Objection – Mistakes/inconsistencies made in the application and/or reports/documentation

Alexander Sebba

EXISTING LAYOUT SURVEY OF 3 HILLFIELD ROAD PROPERTY (IN RED)

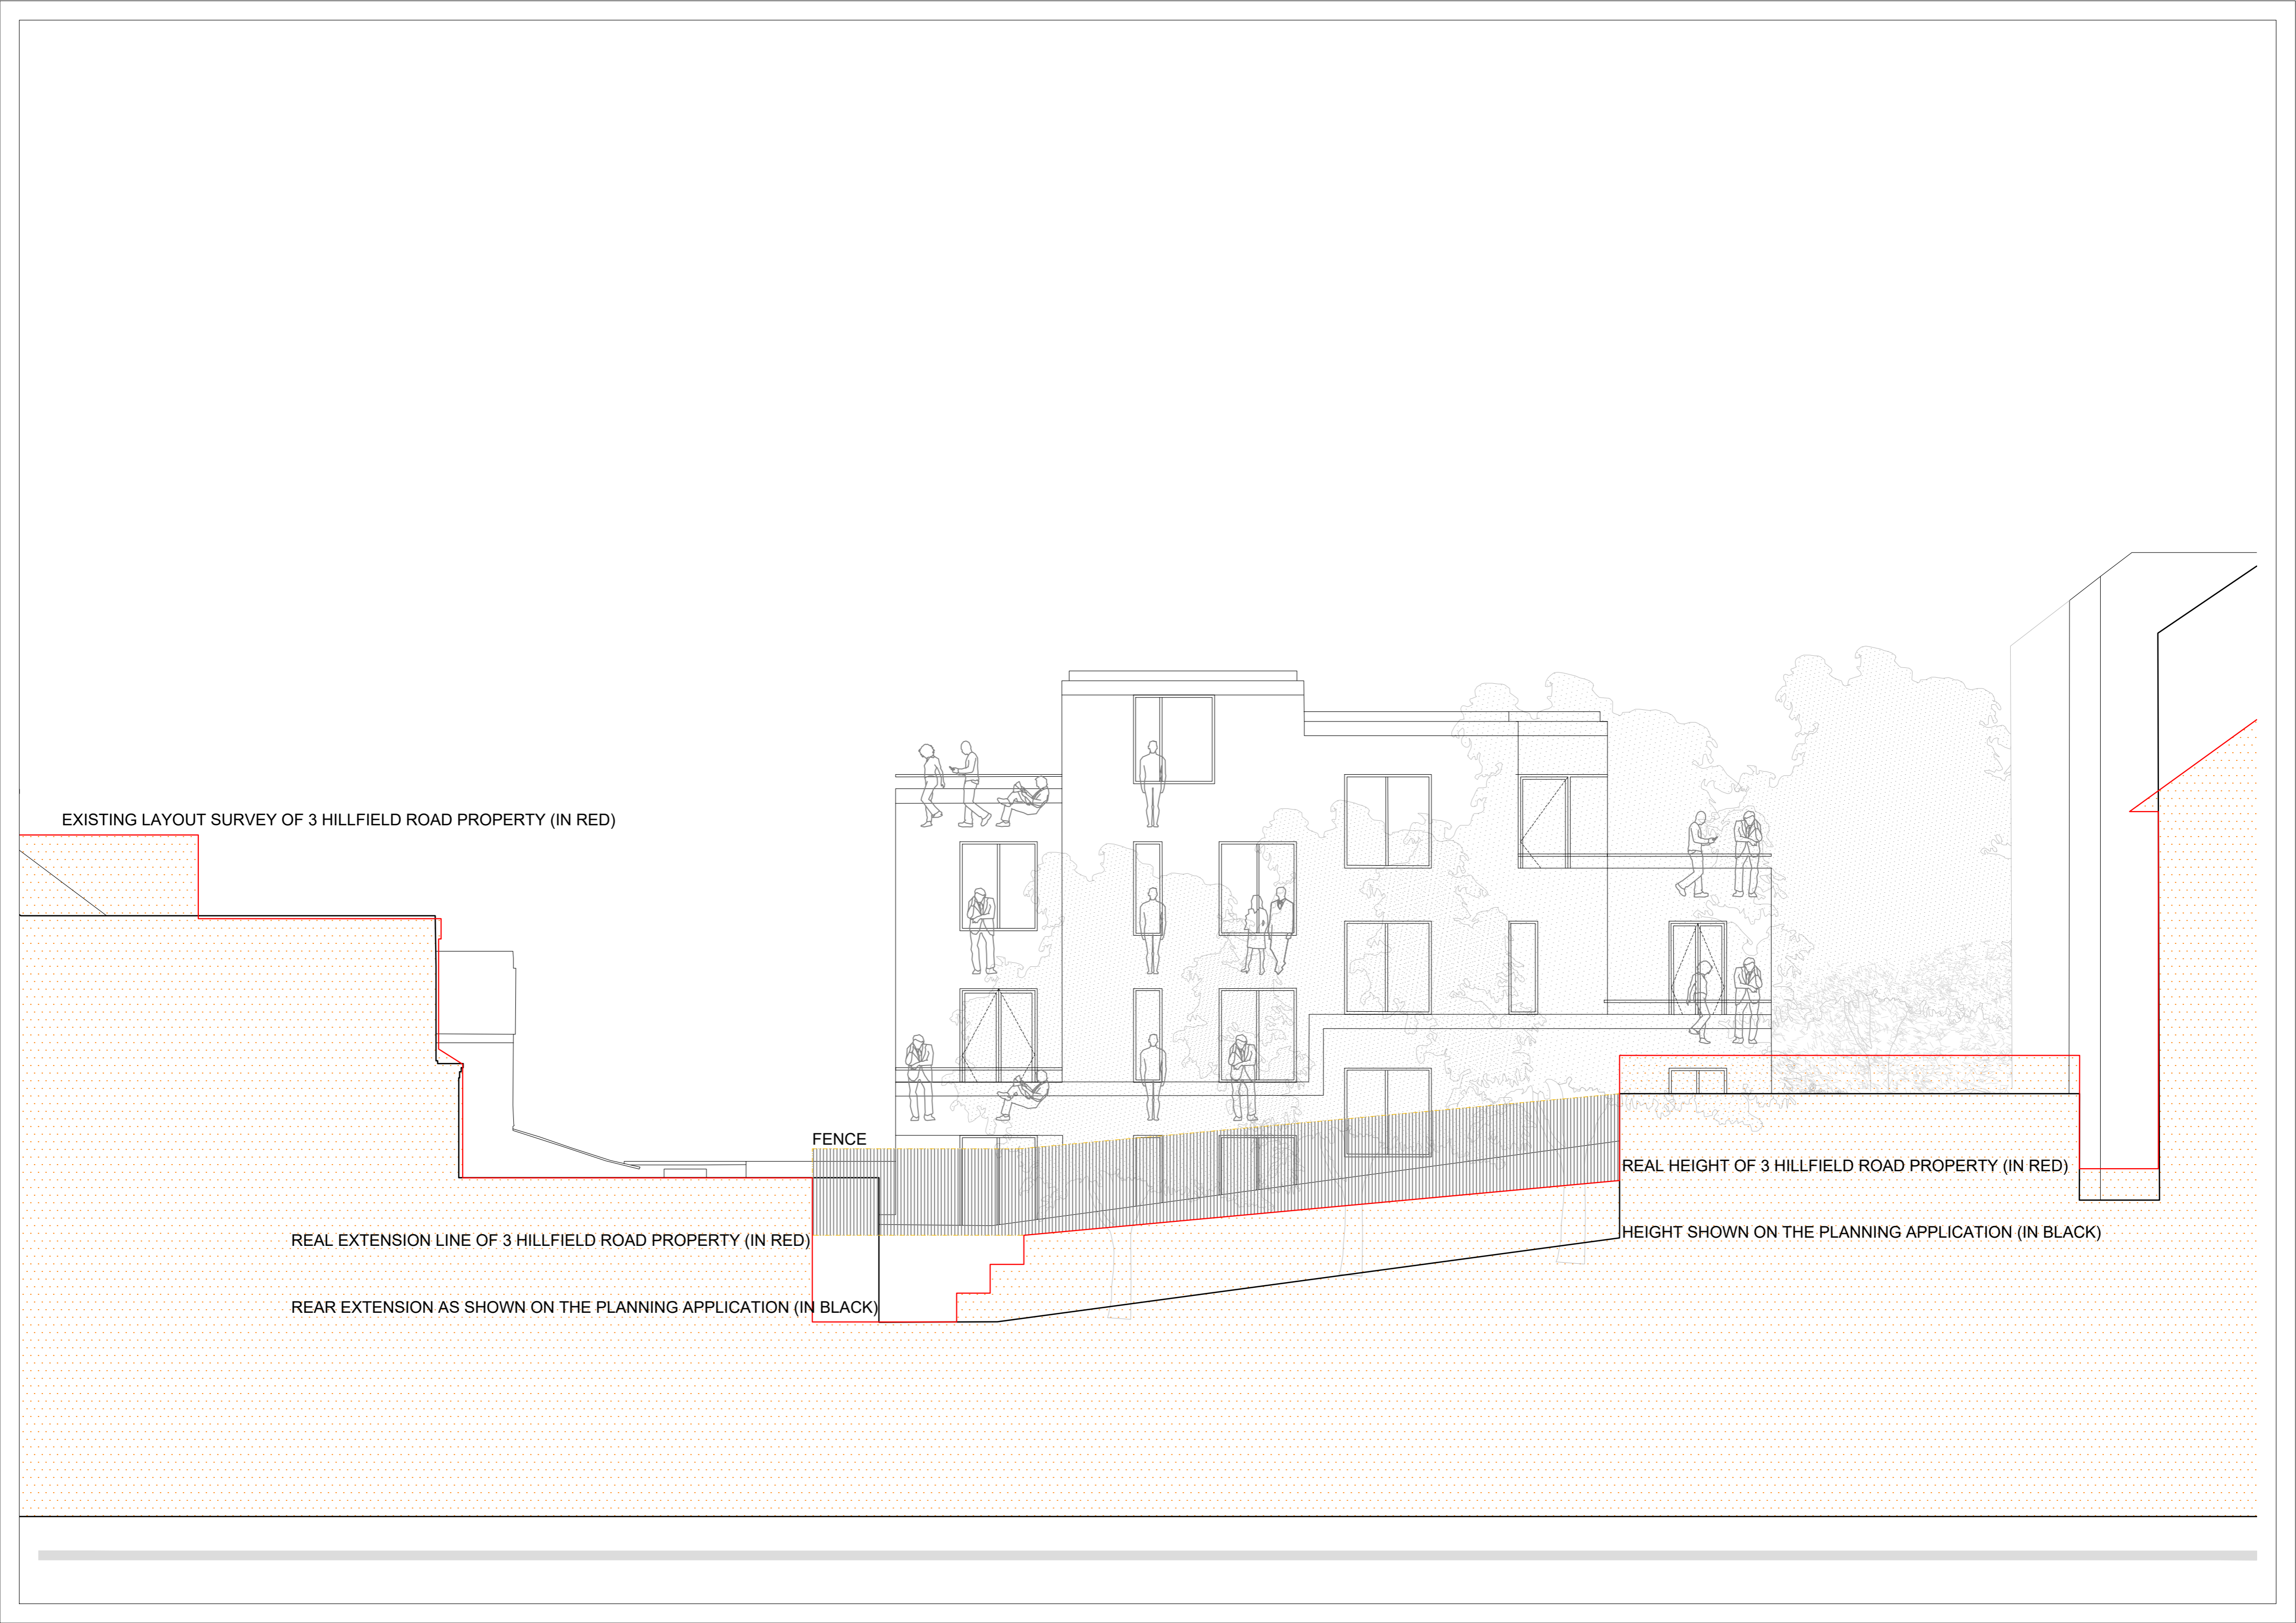
3. The cross section is wrong as the garden of 3 Hillfield is not lower than the garden than 1 Hillfield hence the basement bedrooms will be much deeper and needs to be reassessed. See drawings attached.

4. Windows in the analysis of South Mansion are missing.
5. The topography of the garden is completely wrong as can be seen in the drawings attached this needs to be taken in account for the day light report.

- Land topography to the rear is wrong of the sloping land, see drawing of actual and what drawn.
- Cross section of the land is wrong as the gardens are on the same level.
- Stairs going down to Flat 3 in the new development are shown as 9 steps on the floor plans, 6 on the cross section and appears less on the design and access statement.
- No cross sections going from North to South to show the levels and amenity impact to the 1 & 3 Hillfield Road, especially the terrace to the south that can overlook into property. Two cross sections would be appreciated
  - One through the bin area
  - Across the stairs going down to flat 3
- The drawings show only 6 bins where the design and access statement states 9 bins.

The floor plan shows on 3 Hillfield Road the outbuilding and refers to the rear extension of No 3 Hillfield Road. It refers to the rear extension as “proposed” and refers to the “outbuilding” as built. The rear extension is already built, in fact it was built prior to the outbuilding. 1 Hillfield Road just got planning permission for a rear extension and basement but the BIA does not mention the proposed extension of 1 Hillfield Road. However the BIA states the basement **may** share a party wall with 1 Hillfield Road basement, shows intention to dig 1 Hillfield Road basement up to the boundary not as per the planning drawings of 1 Hillfield Road basement conversion.

REAL EXTENSION LINE OF 3 HILLFIELD ROAD PROPERTY (IN RED)

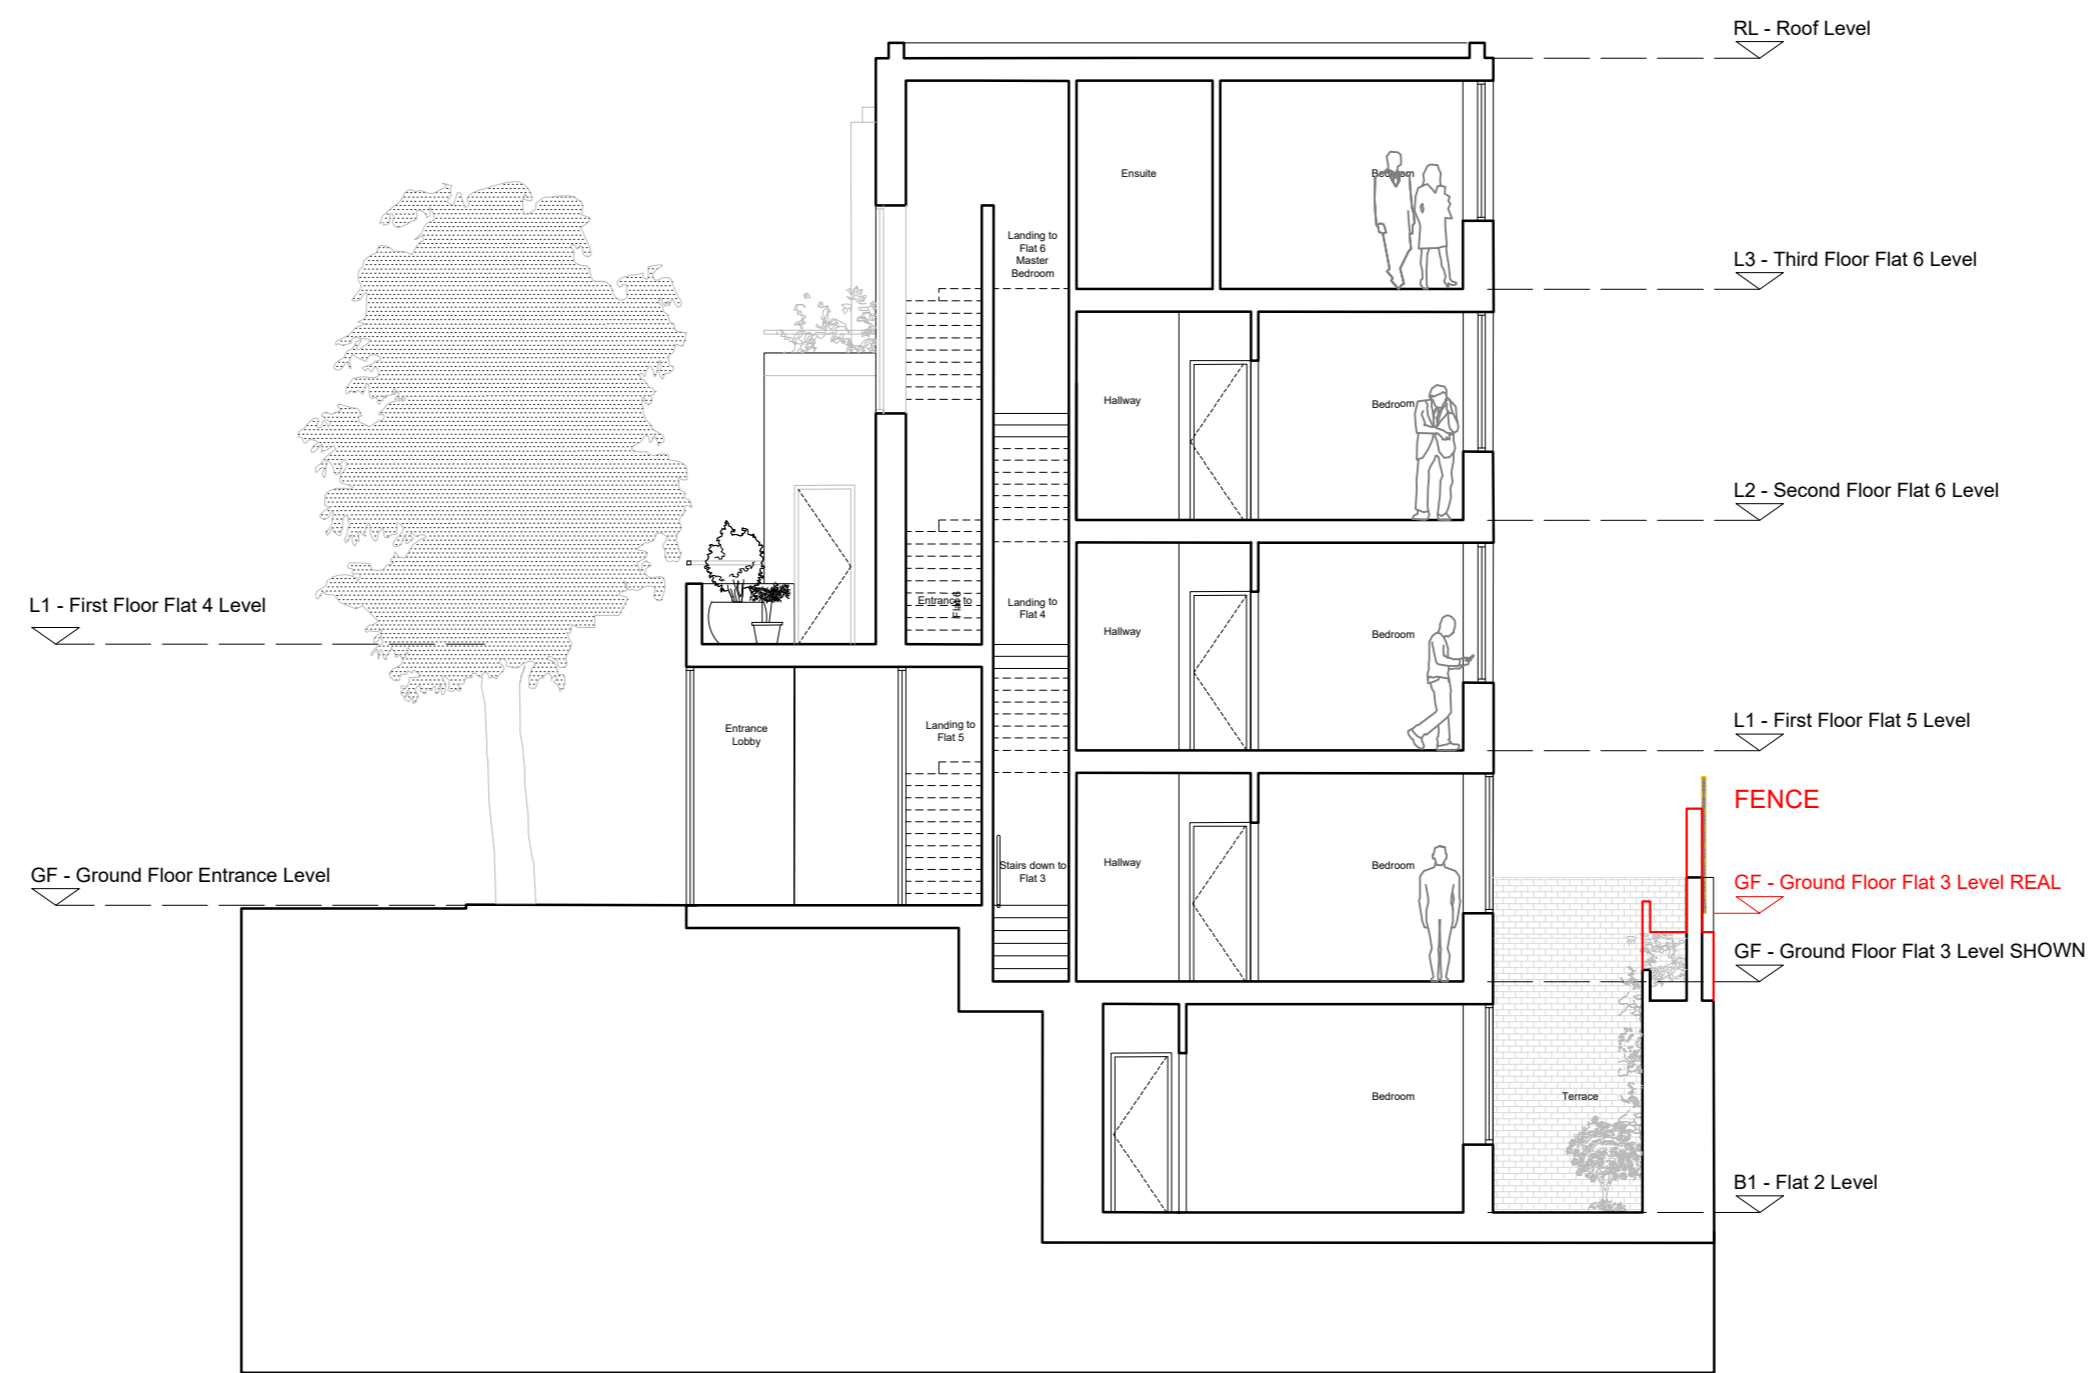
The boundary line is not consistent with what they are showing compared to the ordnance survey maps and the site history. The drawings are not consistent. The extension at No 3 was built with a party wall agreement on No. 3 land and now they are claiming that the wall is a party wall. A boundary dispute has started from the No. 1 and we have engaged a land surveyor report that agrees the extension does indeed belongs to No. 3 and the boundary should be aligned as the OS maps. The main issue they are building right up to the boundary and land grabbing as much as they can.

REAR EXTENSION AS SHOWN ON THE PLANNING APPLICATION (IN BLACK)

REAL HEIGHT OF 3 HILLFIELD ROAD PROPERTY (IN RED)

HEIGHT SHOWN ON THE PLANNING APPLICATION (IN BLACK)
